ADDENDUM #01

DATE:	October 19th, 2022	**PROJECT NO.:**	Project # 20229080 CRSA Project # 21-031
TO:	Gramoll Construction 155 S. 750 W. North Salt Lake, UT 84054	**PROJECT:**	Rio Grande Depot Seismic 300 S. Rio Grande St. SLC, UT 84101

1.AD100

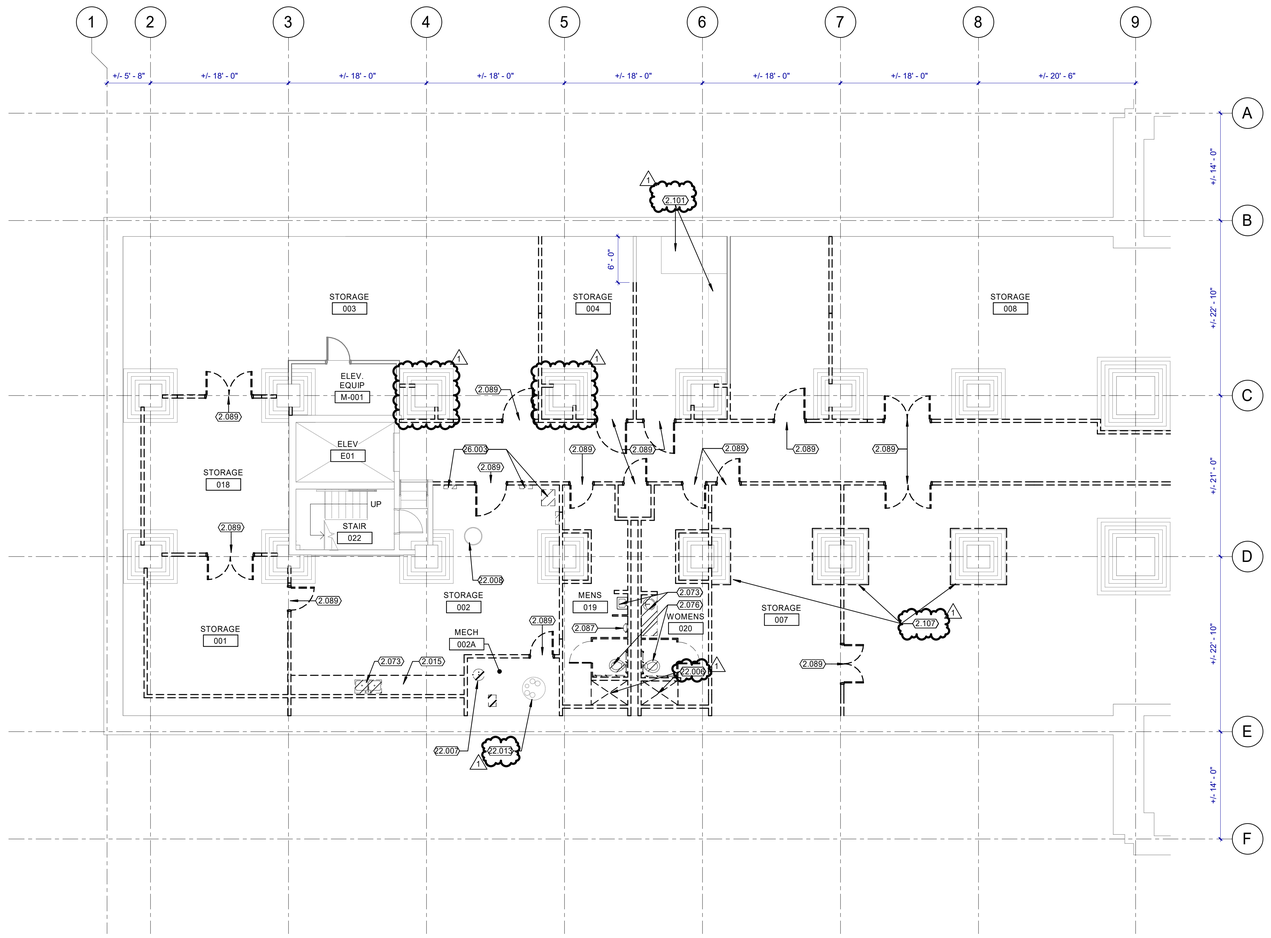
VI-1 1.AD100: Additional existing casework and walls identified to be demolished. Existing concrete shelf shown.
VI-2 1.AD100A: Additional existing casework and walls identified to be demolished. Keynote corrected.
VI-3 1.AD100B: Existing concrete shelf shown.
VI-4 1.AD100C: Additional existing casework identified to be demolished.
VI-5 1.AD101: Additional wall identified to be demolished. Kitchen equipment to be demolished shows more clearly.
VI-6 1.AD101A: Existing casework noted to be demolished or salvaged.
VI-7 1.AD101B: Keynote corrected.
VI-8 1.AD101C: Additional existing marble base to be salvaged identified.
VI-9 1.AD102: Revised room name and number.
VI-10 1.AD102A: Additional existing walls identified to be demolished. Existing trim extents for salvage refined.
VI-11 1.AD102B: Additional existing trim identified for salvage.

1.AD102C

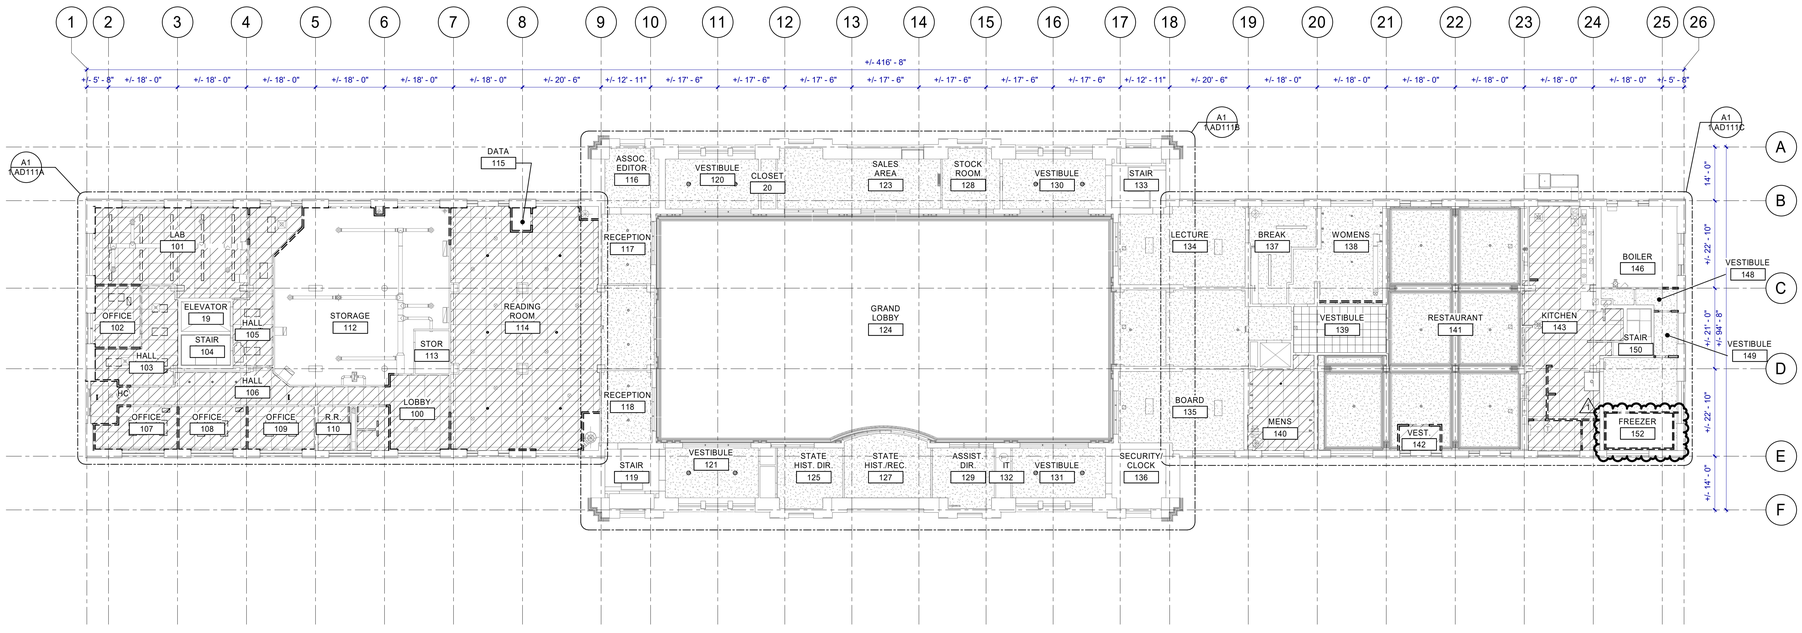
VI-12 1.AD102C: Additional existing walls identified to be demolished. Existing trim and door extents for salvage refined.
VI-13 1.AD111: Freezer 152 ceiling clarified.
VI-14 1.AD111C: Kitchen ceiling hatch for demolition clarified.
VI-15 1.AD112: Hall ceilings changed to be demolished during BP-01.
VI-16 1.AD112A: Hall ceilings changed to be demolished during BP-01.
VI-17 1.AD112C: Hall ceilings changed to be demolished during BP-01.
VI-18 1.AD600: Added doors H8, H9, H17, H18, H19, H28, H29, H30, H41, H42, H44, H46, H47, H60, H69, H80, H81, H85, H86 to scope. Removed doors H39, H40, H84 from scope.
VI-19 2.AD100: Existing concrete shelves shown to be removed.
VI-20 2.AD100B: Existing concrete shelves shown to be removed.
VI-21 2.AD101: Additional floor finishes identified to be removed.
VI-22 2.AD101B: Additional floor finishes identified to be removed.
VI-23 2.AD101C: Additional floor finishes identified to be removed.

2.AD101C

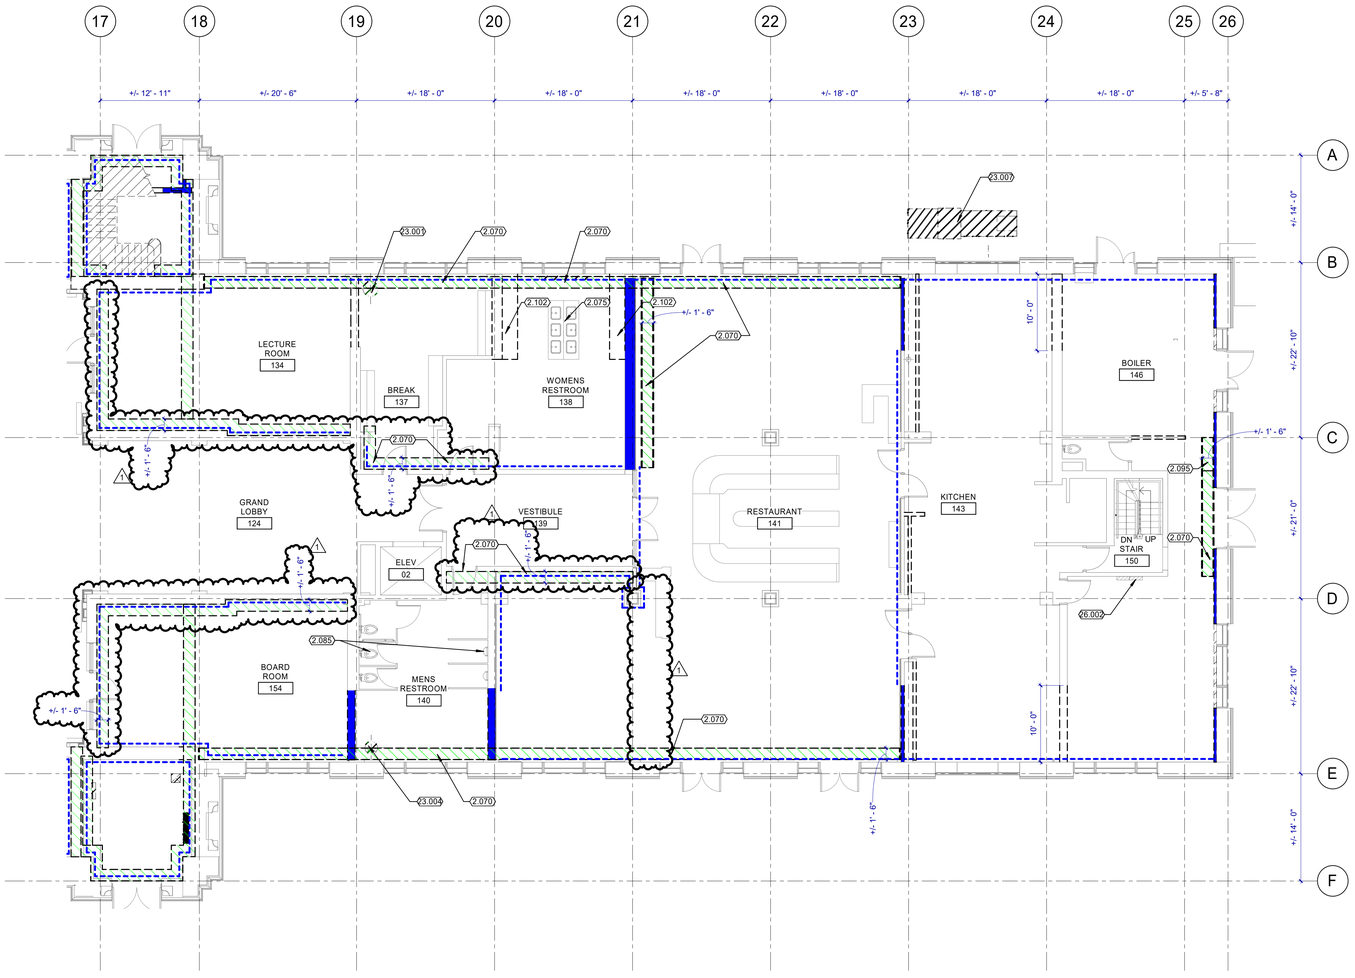
NOTATION OF PLASTER WALLS REMOVED BY OWNER ADDED TO PLAN AREA C

SD101B

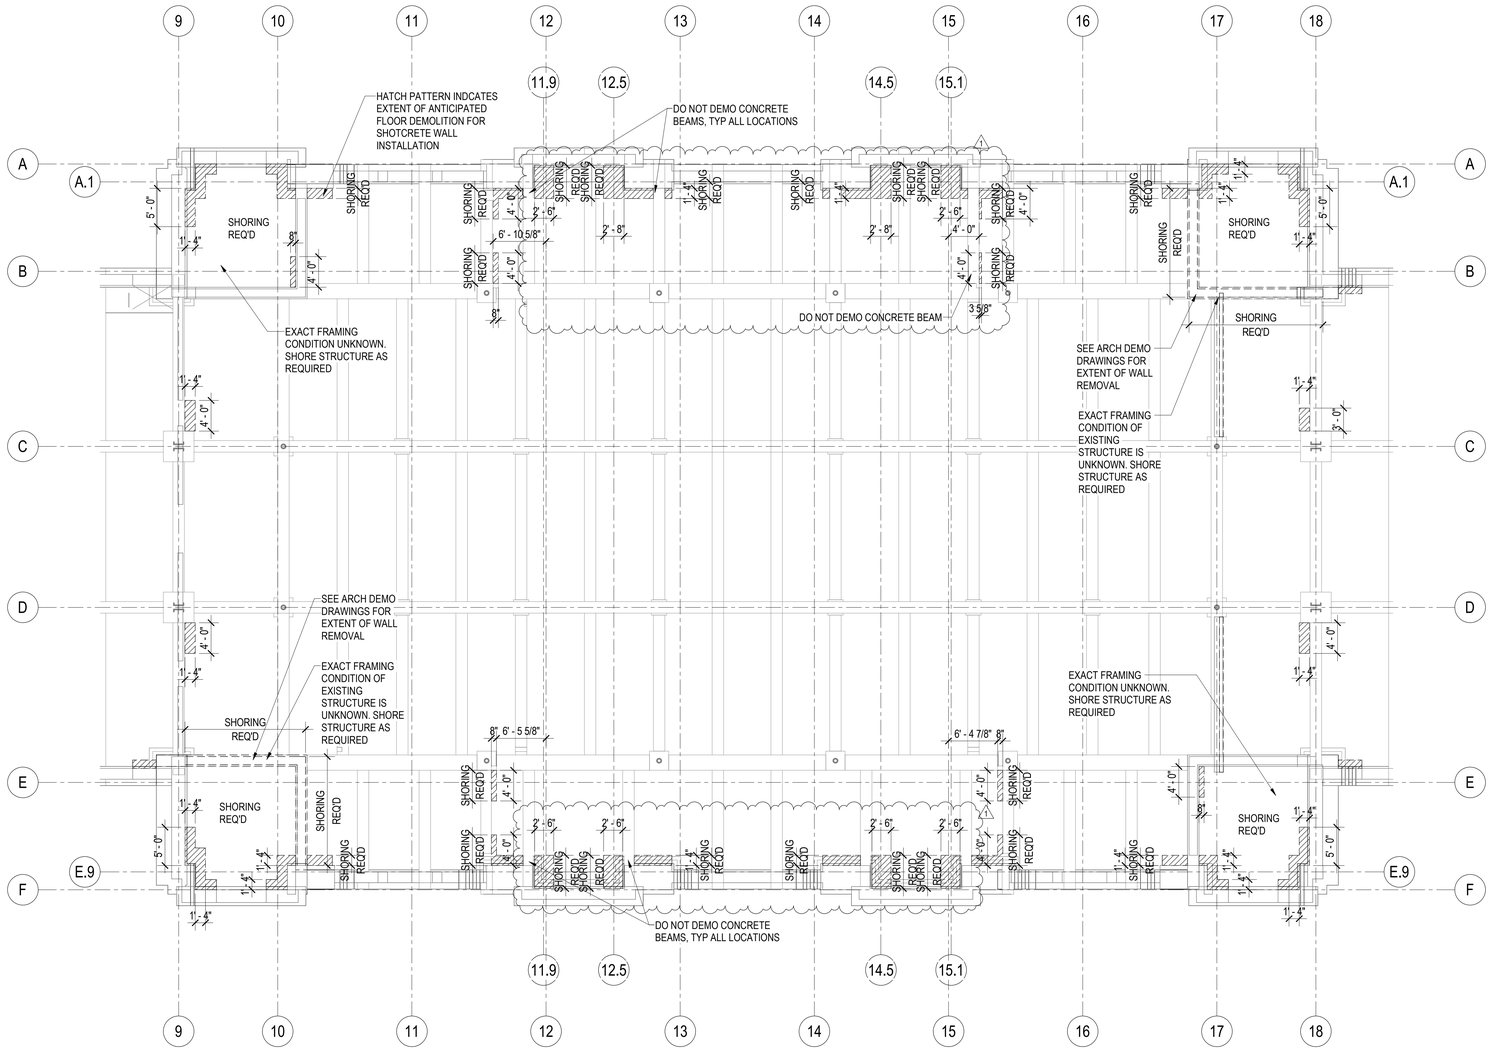
1. Revision in demo required near the (8) concrete columns

SD102B

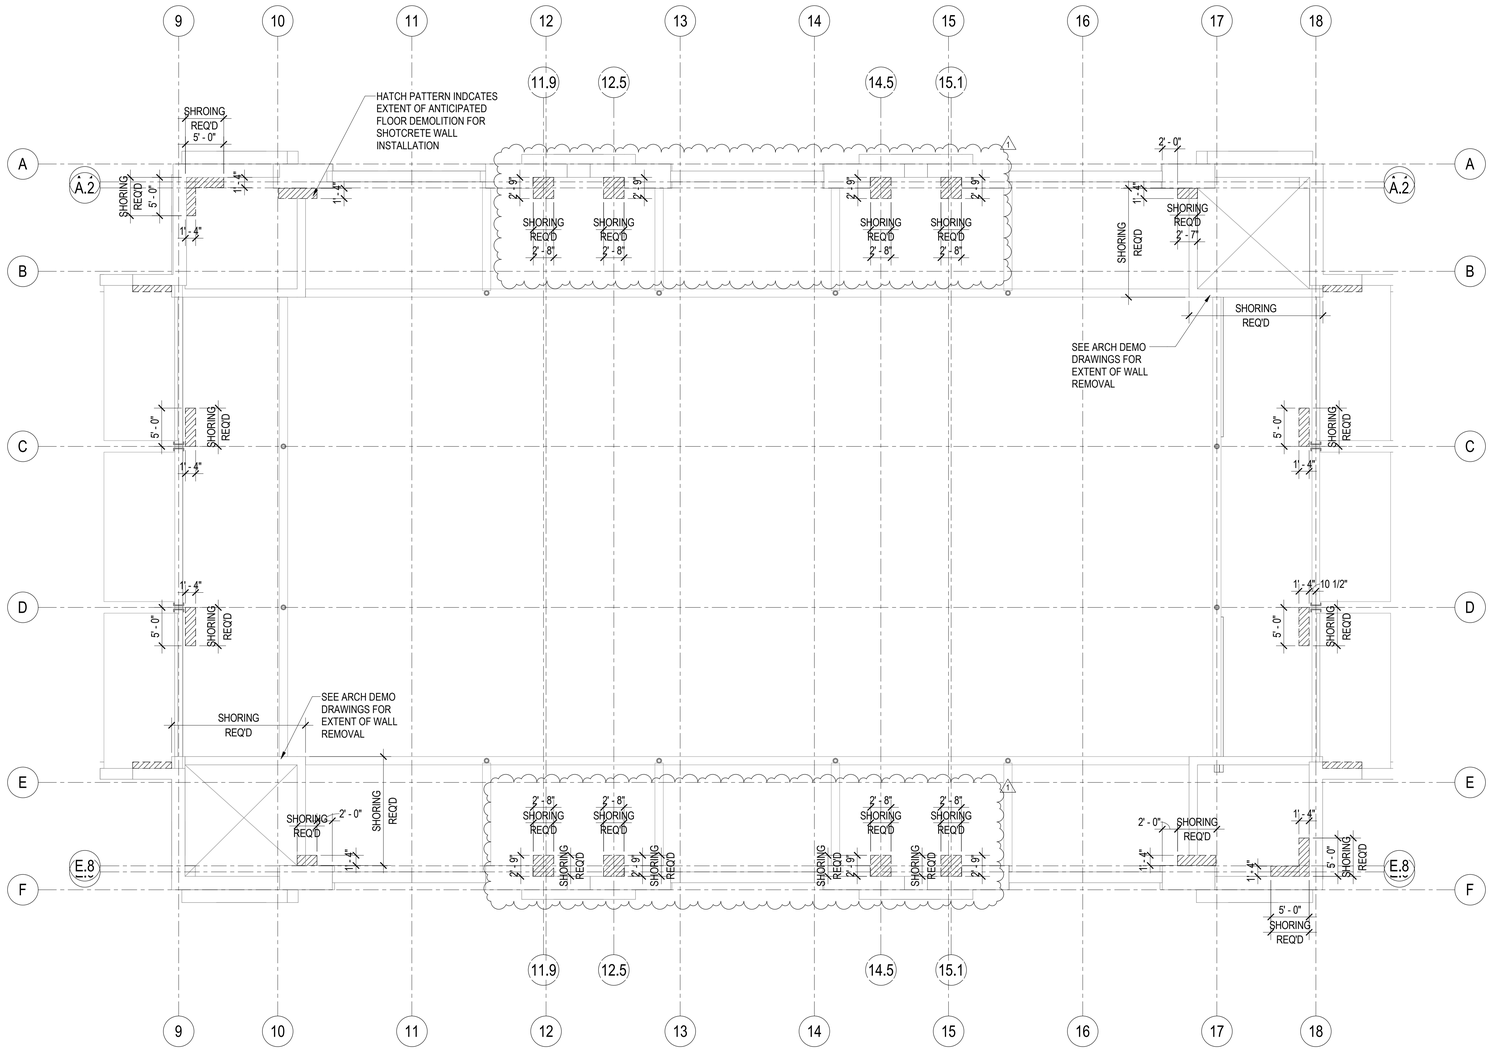
1. Revision in demo required near the (8) concrete columns
